TR1: TRANSITION REPORT

Date of Report: (DD/MM/YYYY)	22/02/2023	Report Version:	1
Product Identifiers: FROM	MEM2051 rev D1	TO:	MEM2052 rev A

Comparison of product drawings:

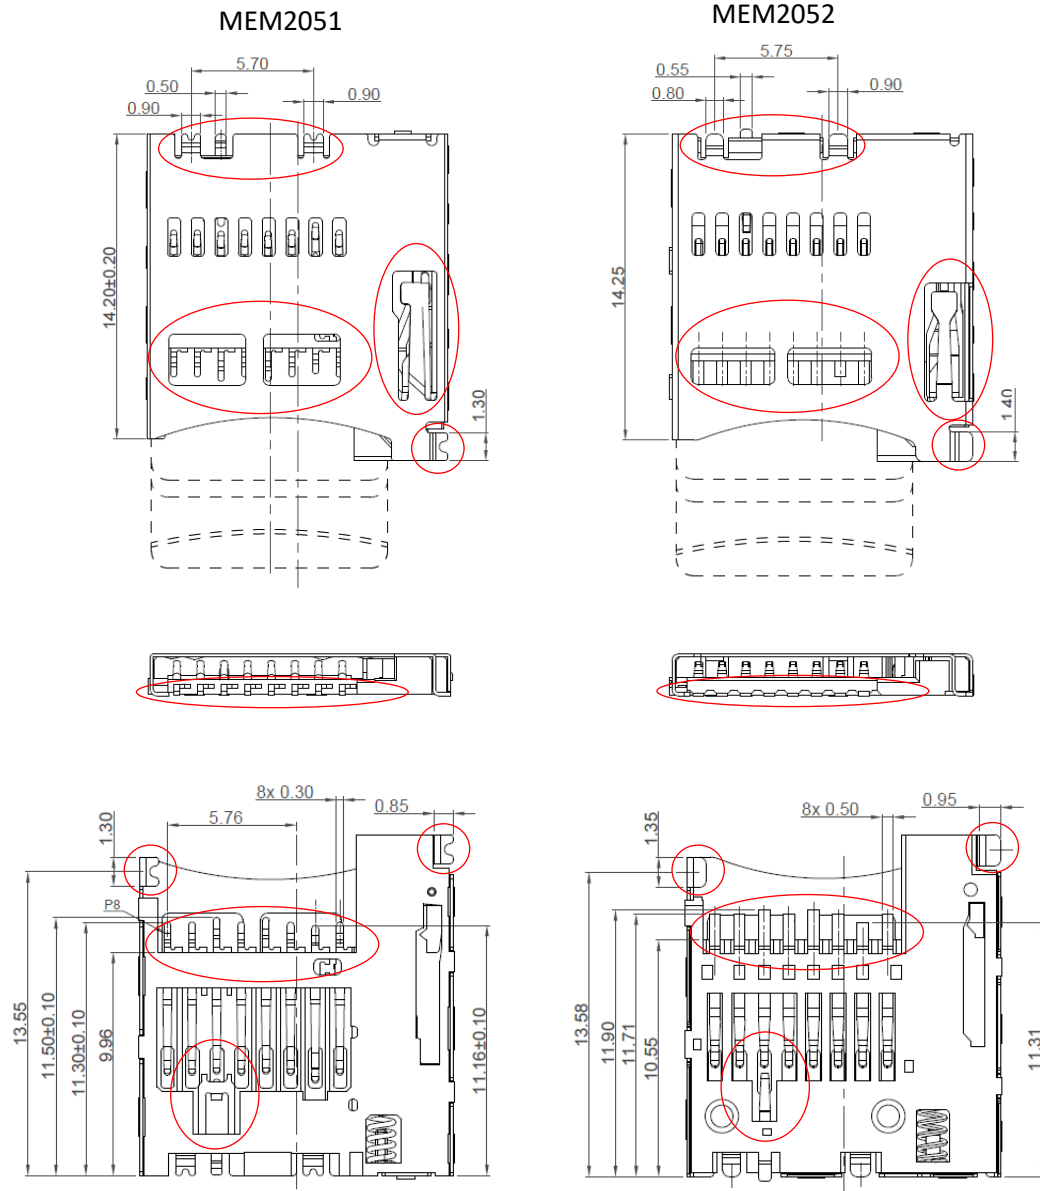
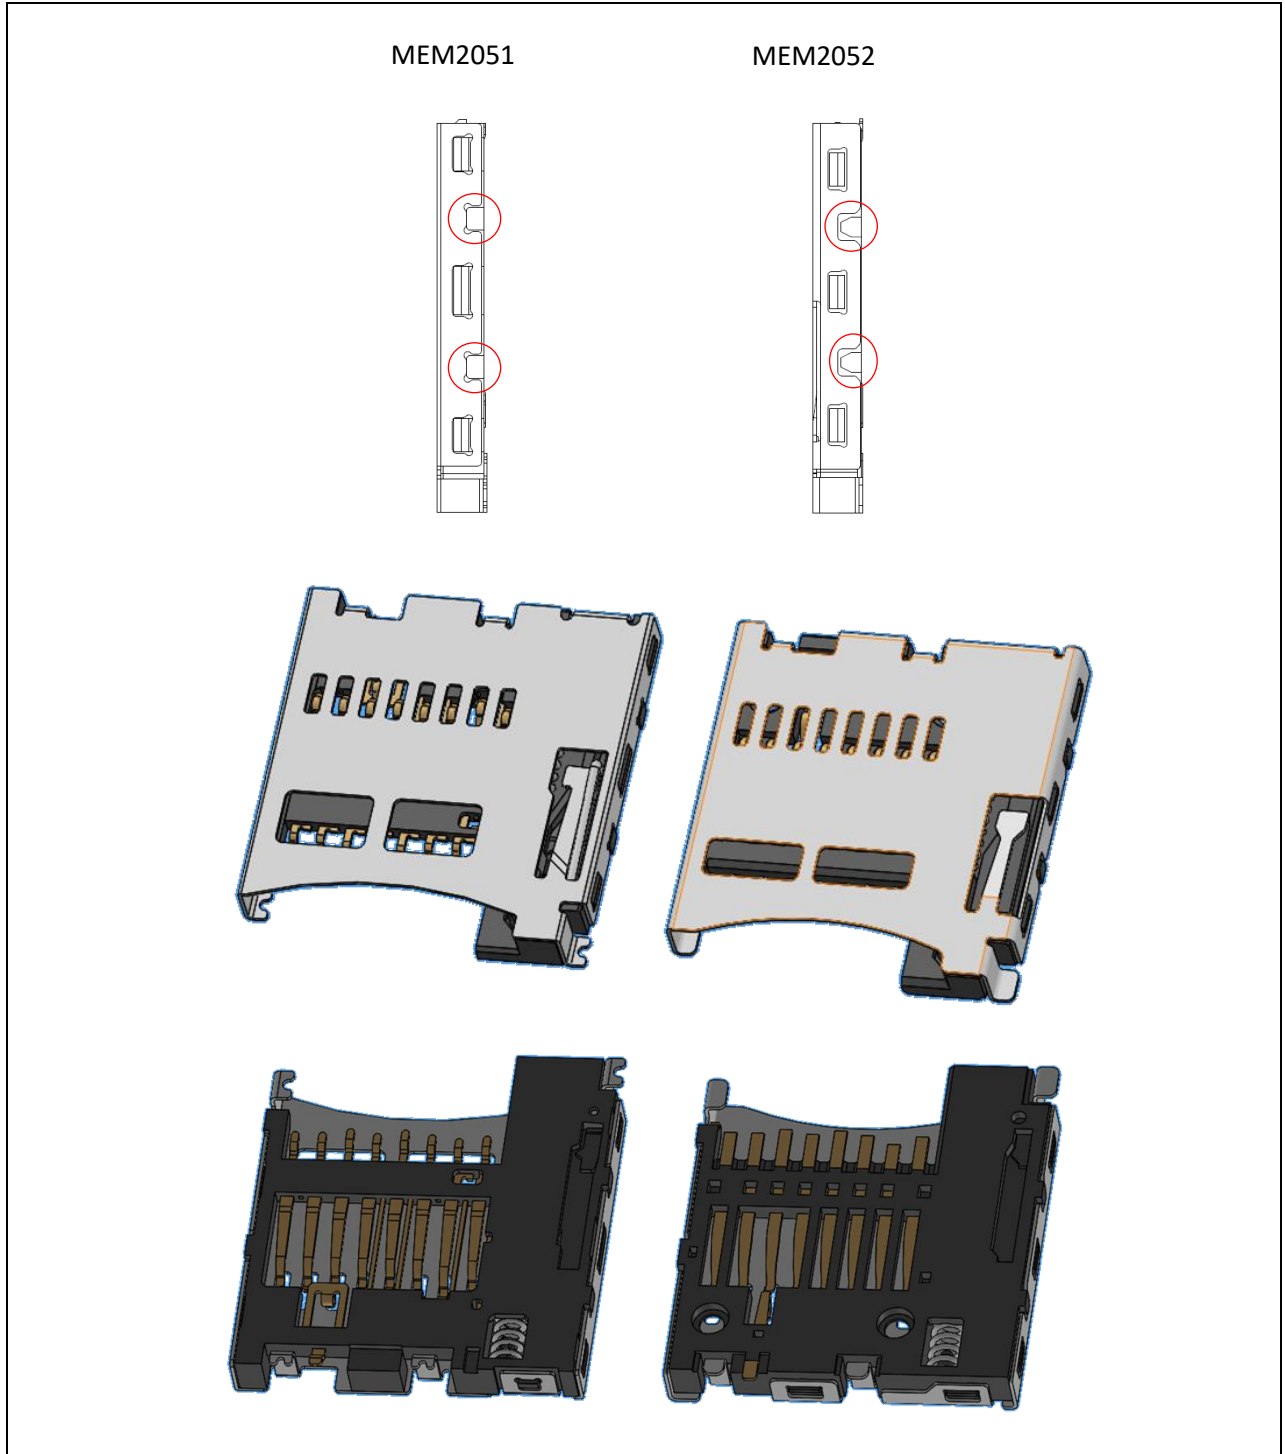
FORM & DIMENSIONS: Minor differences on dimensions and appearance, please see below drawings comparison

Comparison of product footprints.

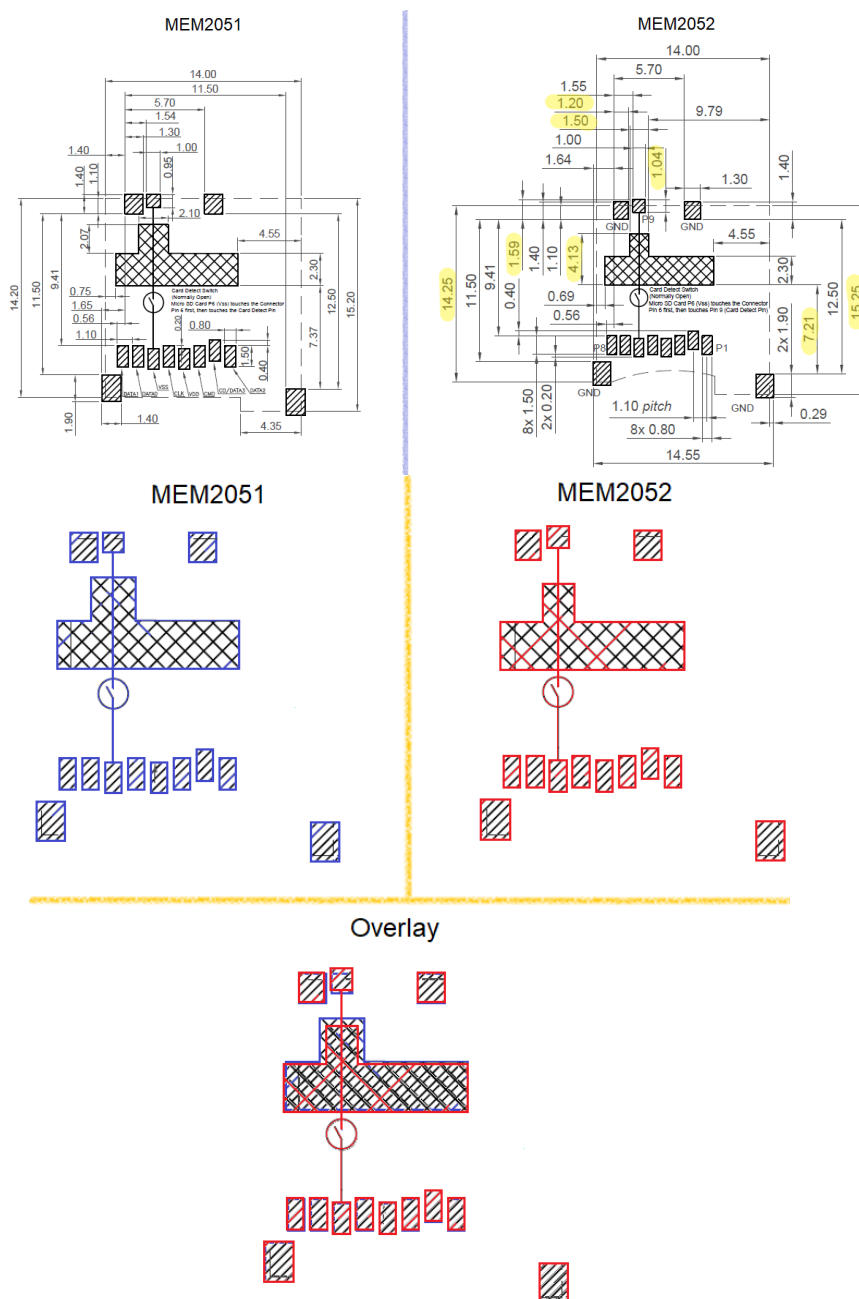
FOOTPRINT/LAYOUT: Please see below comparisons of footprints. Minor differences on dimensions. Footprint of MEM2051 is applicable for MEM2052.
